SCS ENGINEERS

Mr. Kim Ford, P.E.
Solid Waste Permitting
Florida Department of Environmental Protection
3804 Coconut Palm Drive
Tampa, Fl 33619

Subject: Southeast County Landfill Permit Renewal - Responses to Additional Information Request

TABLE 2.

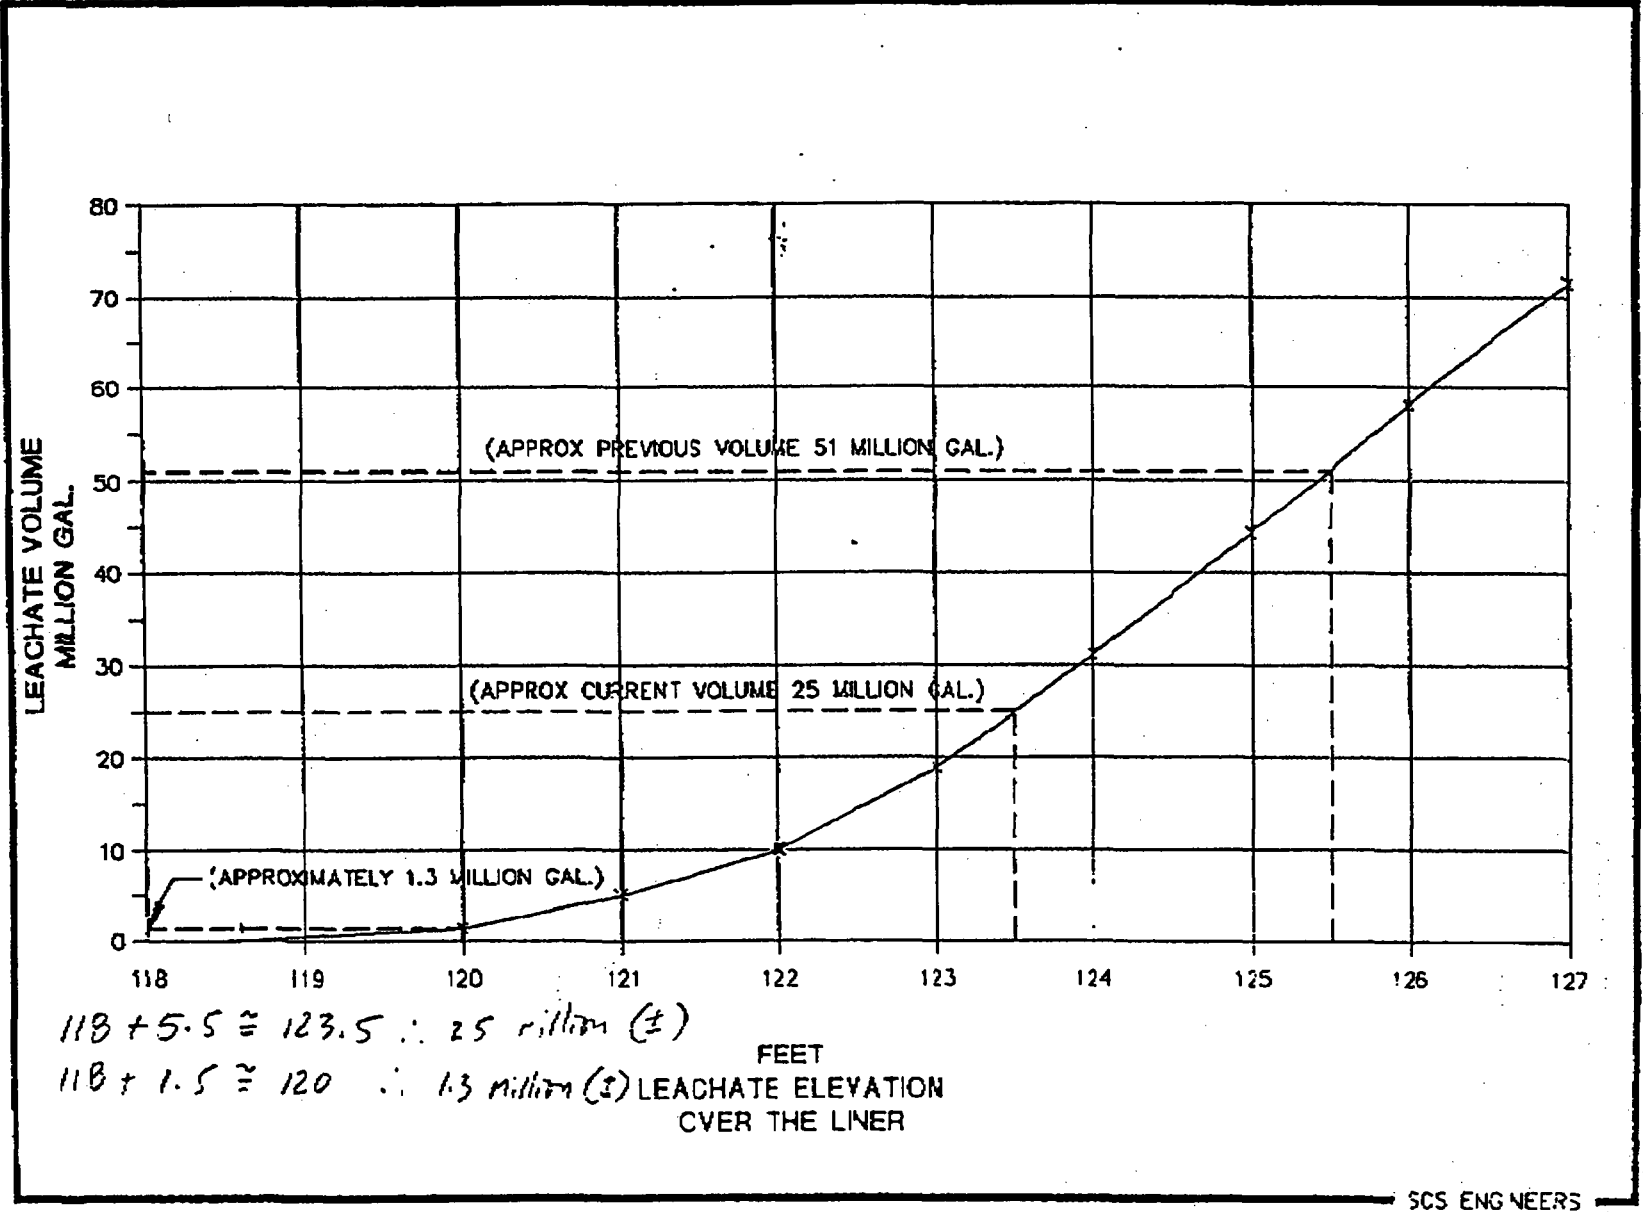
FDEP Request 1 - Based on the performance of the leachate collection system and current pumping data, reevaluate the amount of leachate over the liner, the amount of time required to lower the leachate head, and the sump area.

Response - The current withdrawal rate and levels are monitored daily and are shown in Attachment 1. The flow into pump station No. 3 will vary as leachate levels are lowered. SCS anticipates that once leachate levels in the sump reach approximately 15 inches or lower, a disposal rate of 150,000 gpd will not be obtainable (See Attachment 2). SCS estimates that at a disposal rate of 150,000 gpd it will take approximately 6 months to reach the condition described above.

leachate volume to 5.5 = 25 mill gal.
 leachate volume to 1.5 = 1.3 mill gal.
 (Table 2 attached)

$118 + 5.5 \approx 123.5 \therefore 25 \text{ million } (\pm)$

$118 + 1.5 \approx 120 \therefore 1.3 \text{ million } (\pm)$

Figure 1. Leachate Collection System, Southeast Landfill.

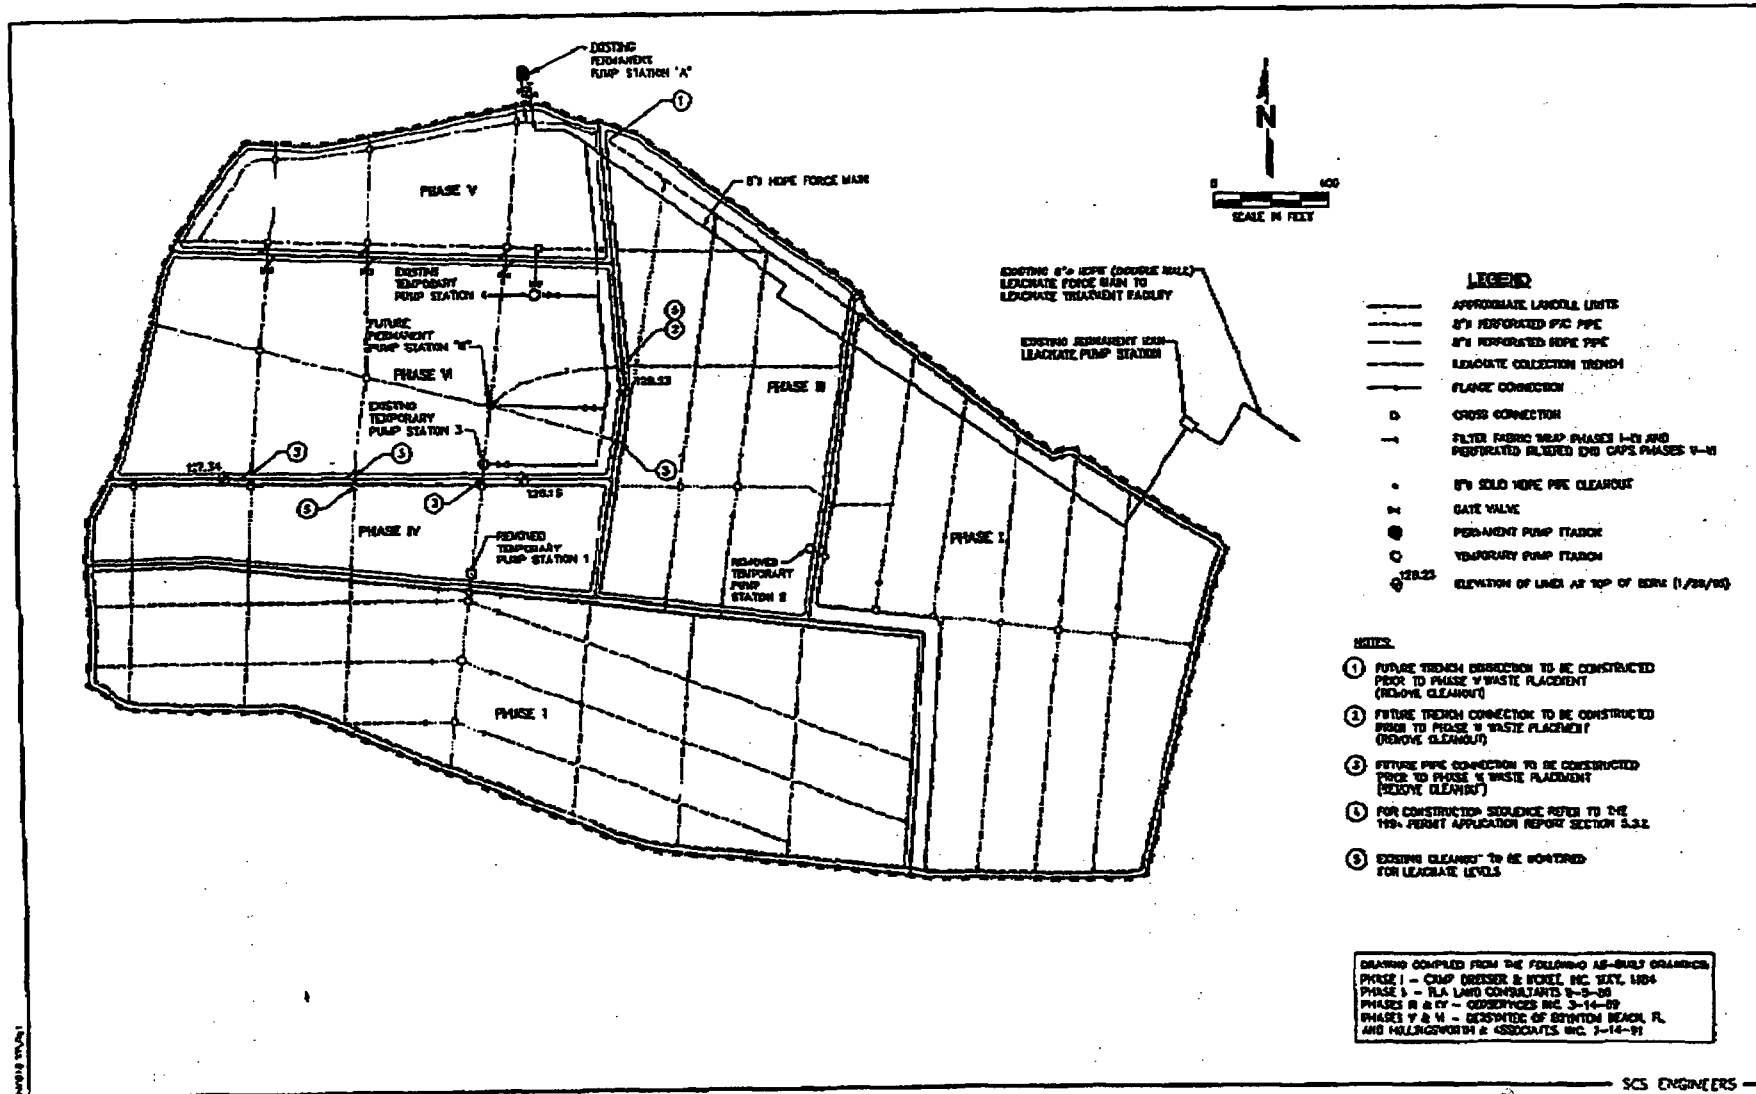
FDEP Request 3 - Evaluate expanding the Landfill monitoring program to include Phases III and IV leachate levels, raw leachate storage tank, and stormwater levels within Phases V and VI.

Response - The leachate monitoring program was expanded to monitor leachate levels in the existing clean outs in Phases III and IV (See Note 5, Figure 1), and the leachate storage tank at the on-site Leachate Treatment Facility on daily basis. In addition, the water levels are monitored in the temporary pump station No. 4 to maintain the water levels in Phases V and VI at least equal to leachate levels in Phases III and IV so that the 12-inch hydraulic head is not exceeded on the synthetic liner along the interior berms of Phases III and IV. The water depth in the temporary Pump Station No. 4 will be monitored and maintained to a level at least 6 inches higher than the leachate level depth in Pump Station No. 3 (See Figures 2 and 3).
